SPRINGS LOFTS

RFI#: 37 Date: 1/23/2012 Job: EB-02 Keller Springs Lofts Phone: 877-777-5115

Date Required: 1/25/2012 Request: On sheet P-3.0C the main sanitary trunk line is shown running in the center of the corridors. It is 6" running north along the east side of the garage. It joins another 6" running east along the north side of the garage. So we have a 6" joining with another 6" but there is no designation as to the size of the line after that until it meets the 10" that leaves the building. Sheet P-3.0E gives no designation to the size of this line either. I feel this may be an oversight and the intention would be to have the large to an 8" after the (2) 6" lines merge. Please advice and respond as we are going to be installing these lines in the next two days.

P-3.1C

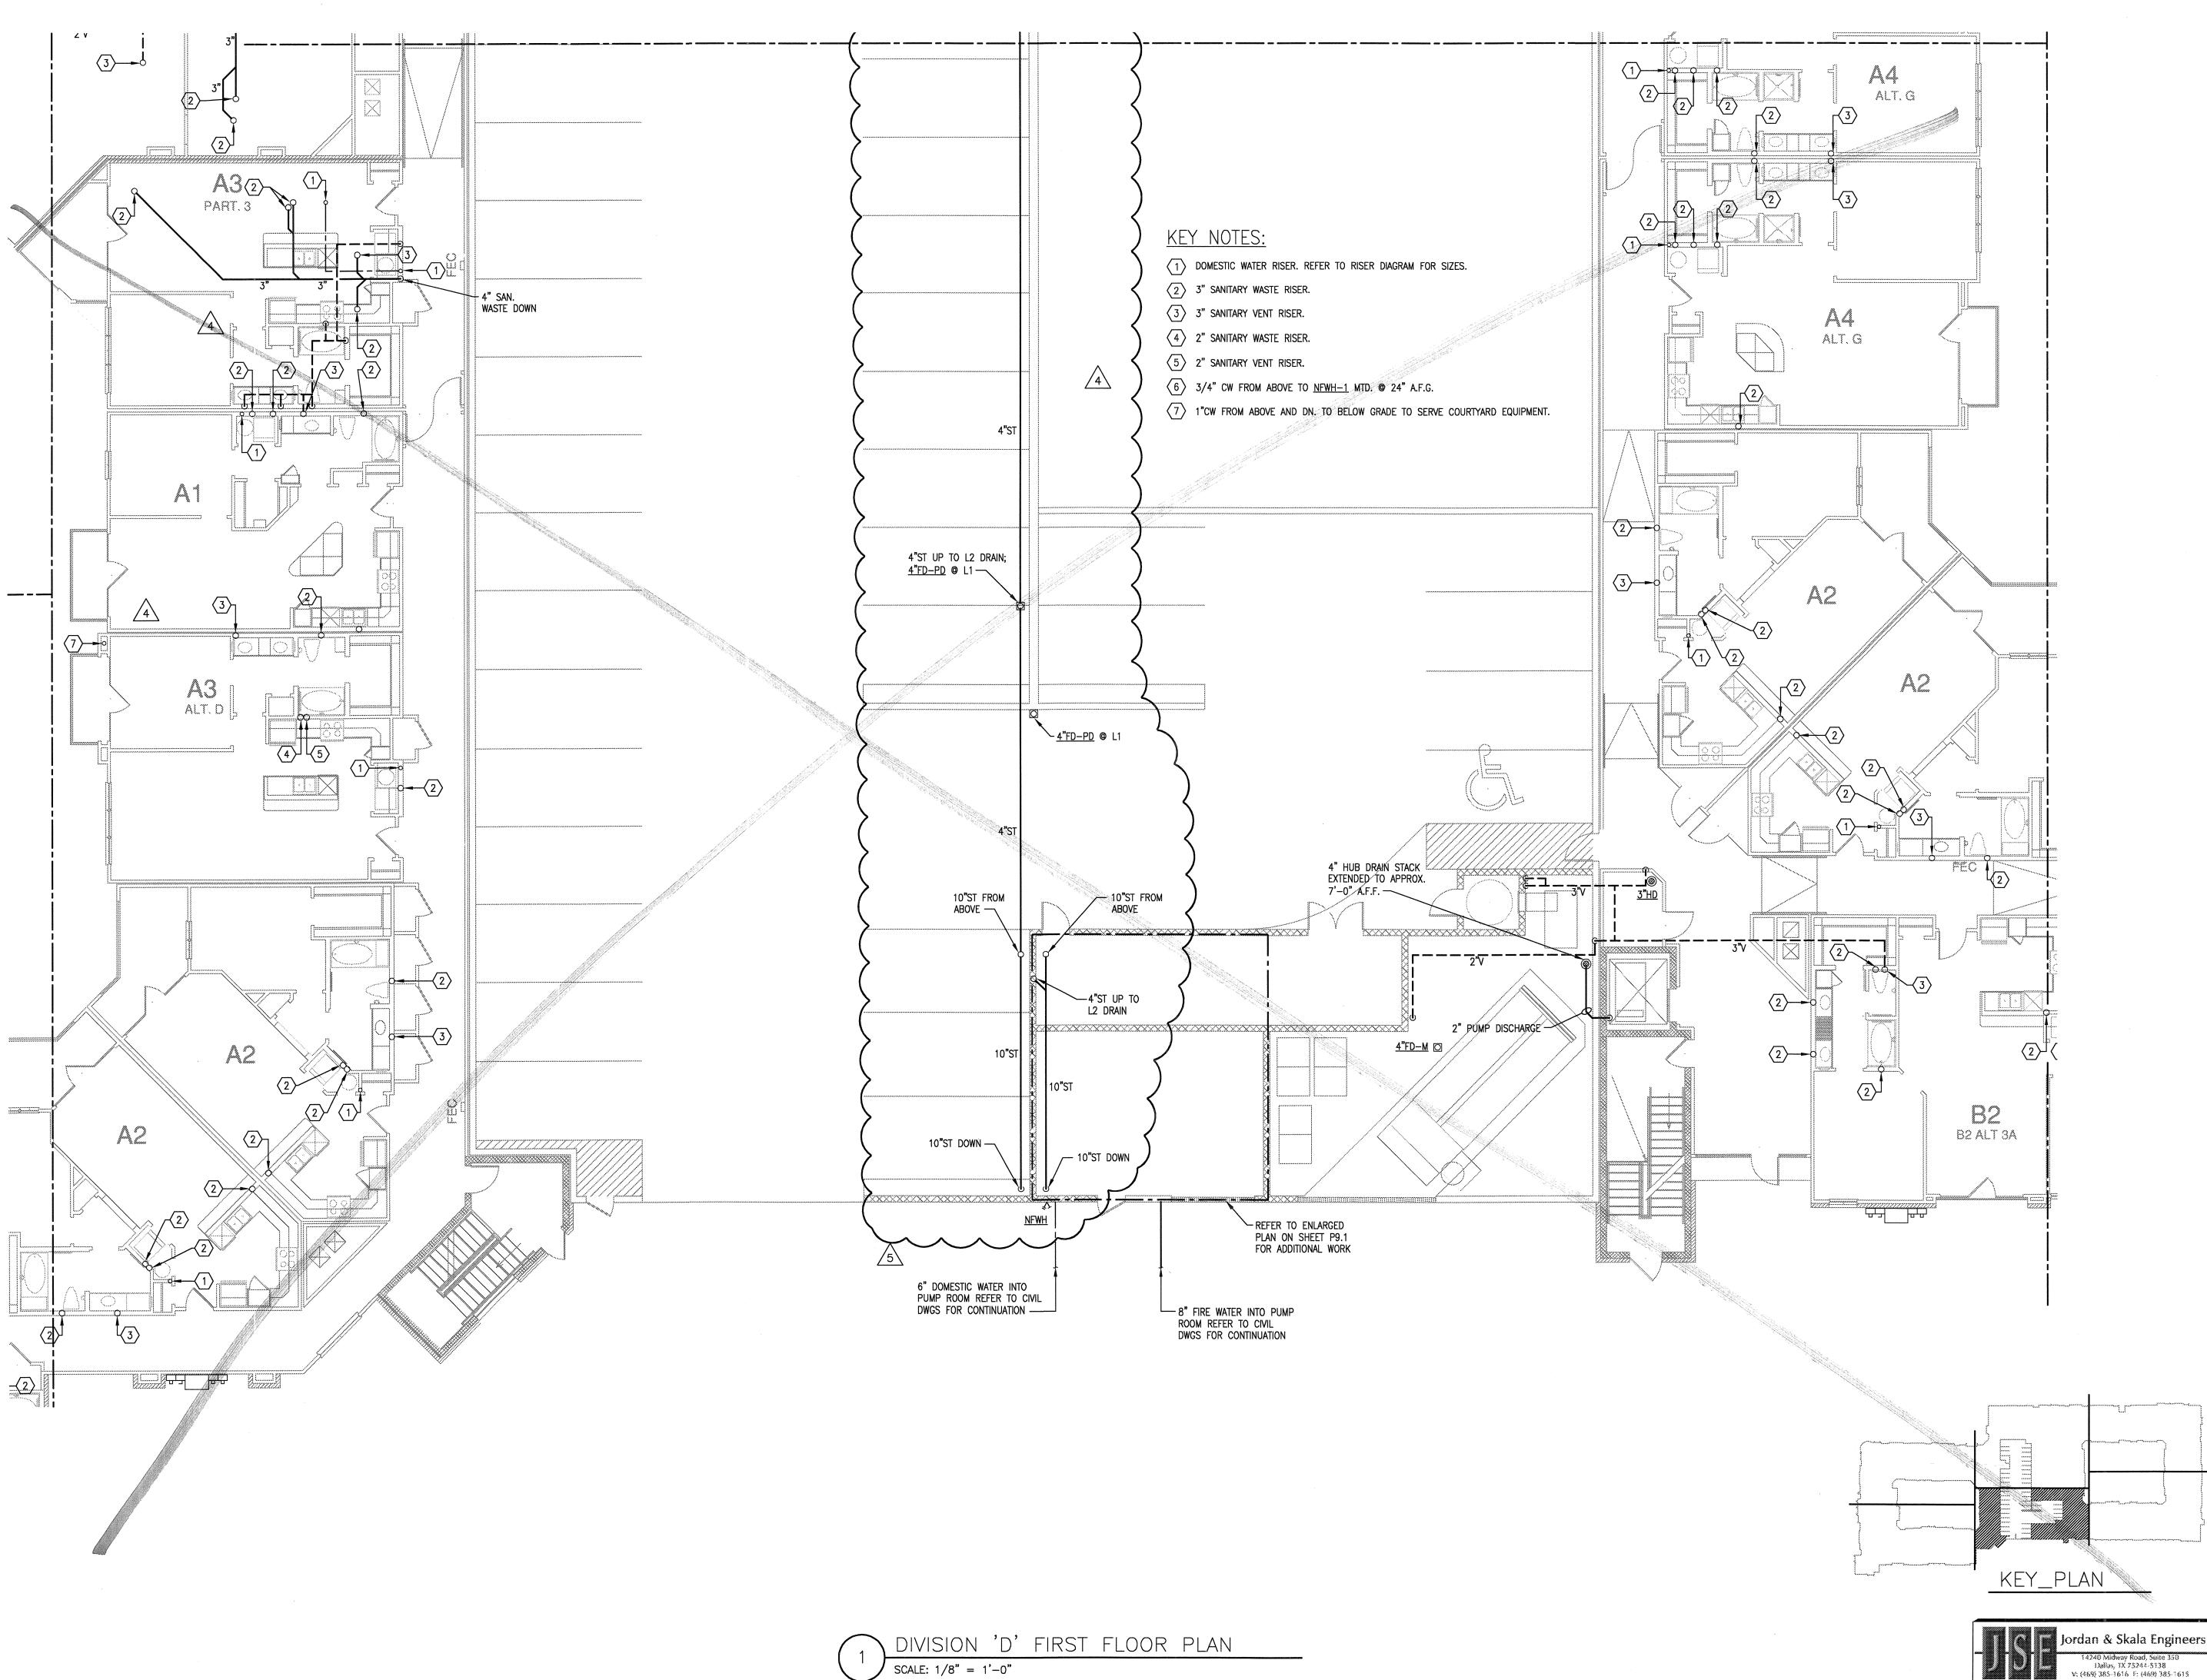
The location for the gas meter appears to have changed from its original location reflected on C 10 on the Civil Plans. The new location appears on the Jordan Skala
SK-P1 dated 01-19-2012. It is on a completely different part of the building from C 10 and slightly different than P-3.1C. Attached is SK # 1 which is where it's located on C 10. SK # 2 reflects where I feel it is intended to be located. SK-P1 is the revised sketch by Jordan Skala locating it where we believe it is supposed to go. I need confirmation that it does go the way I show it on SK #2 and as shown on SK-P1.

The gas meter should be located in the spots shown on SK#2 and SK-P1.
